Serial: RNP-RA/02-0009

H. B. ROBINSON STEAM ELECTRIC PLANT, UNIT NO. 2  
DOCKET NO. 50-261/LICENSE NO. DPR-23

RESPONSE TO NRC REQUEST FOR ADDITIONAL INFORMATION  
FOR THE FOURTH TEN-YEAR INTERVAL INSERVICE TESTING PROGRAM PLAN

# FCV-1933B

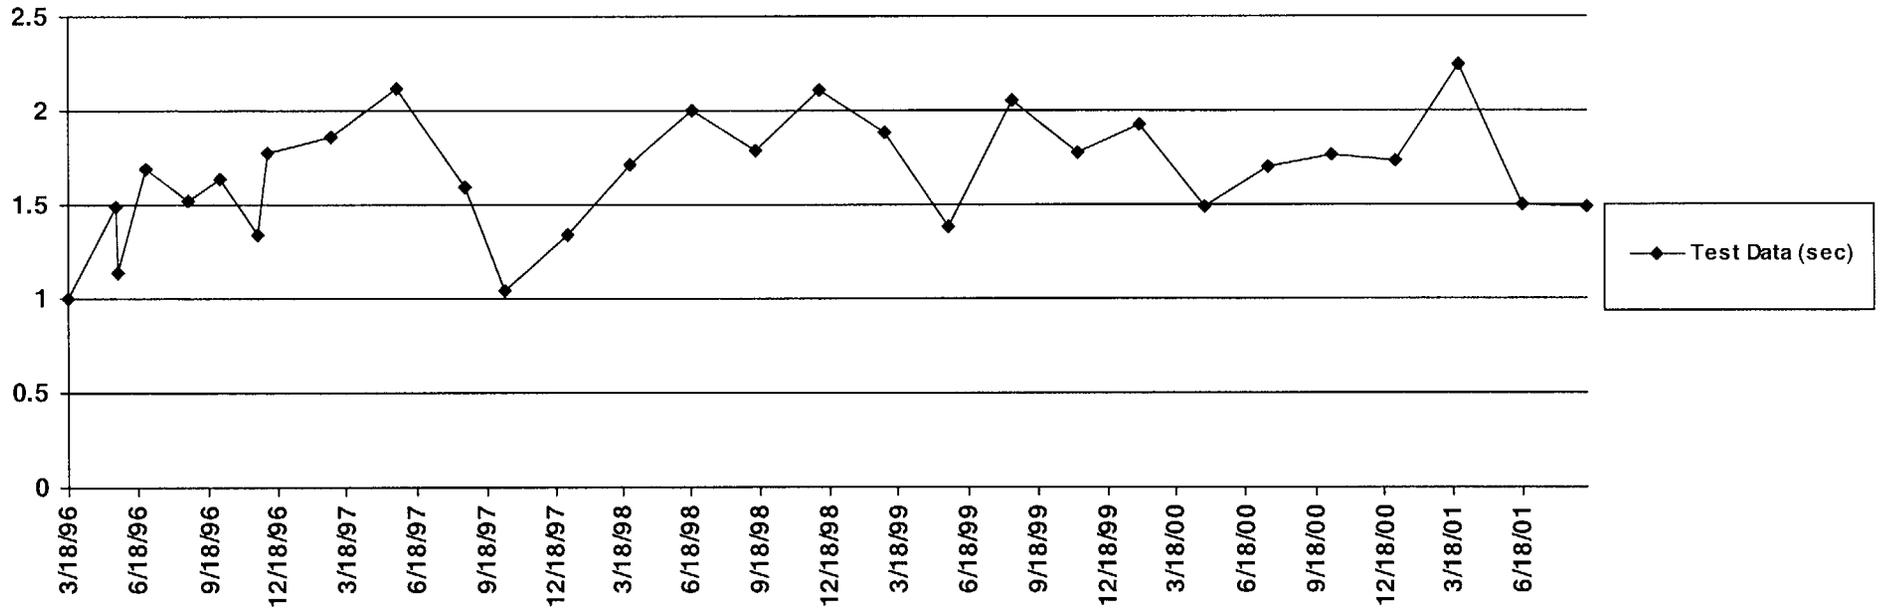
Example 2: FCV-1933A

# FCV-1934B

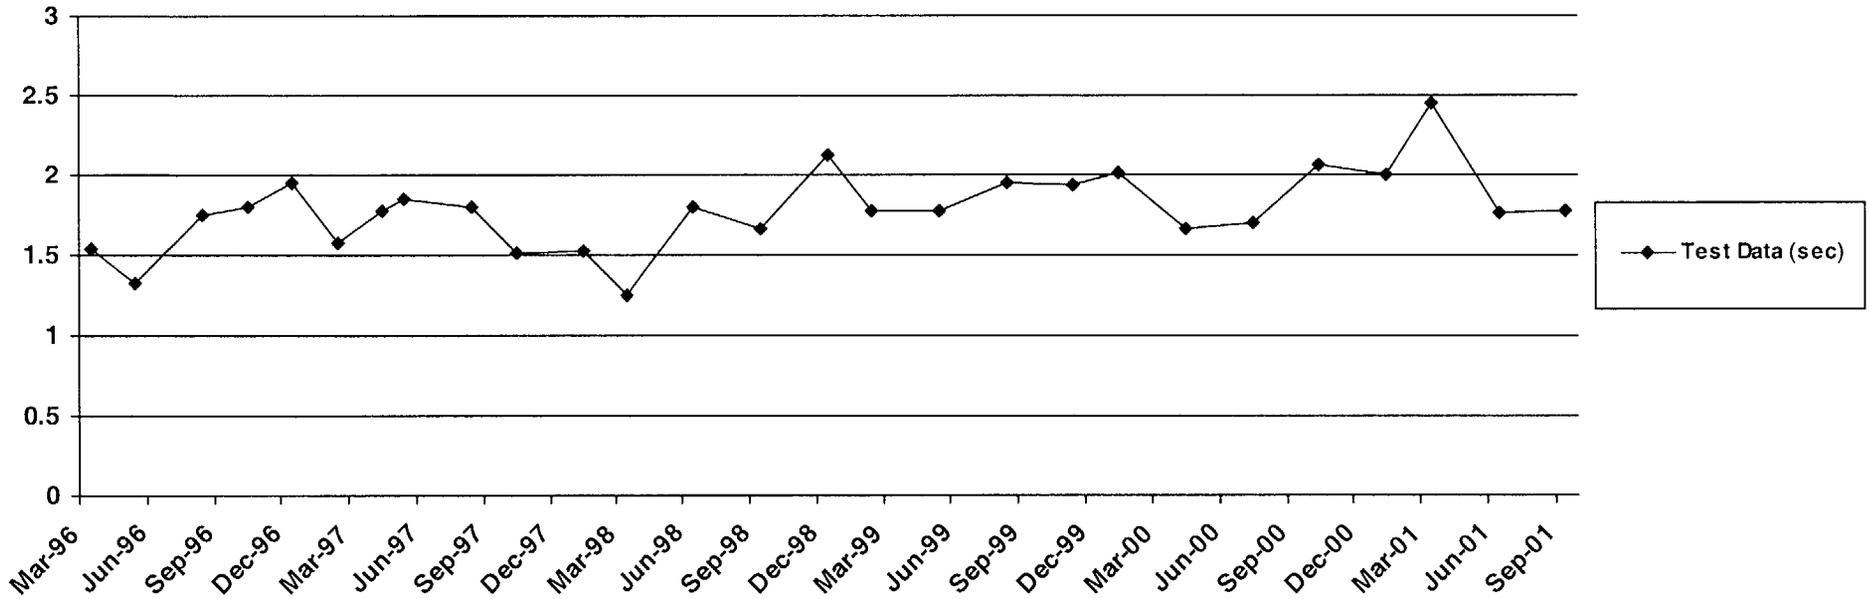
The subsequent test result on 12/5/98 exceeded the upper 50% acceptance limit; however, the proposed upper 75% limit would have been met. Additionally, no corrective action thresholds associated with the ASME Section XI – 1986 requirements were triggered based on the 12/5/98 test result. The subsequent test on 2/28/99 further showed that the valve was not exhibiting an adverse trend. Additionally, no maintenance was performed on this valve in the time between the 12/5/98 and the 2/28/99 tests that would have caused the result to change from 2.27 to 1.66 seconds.
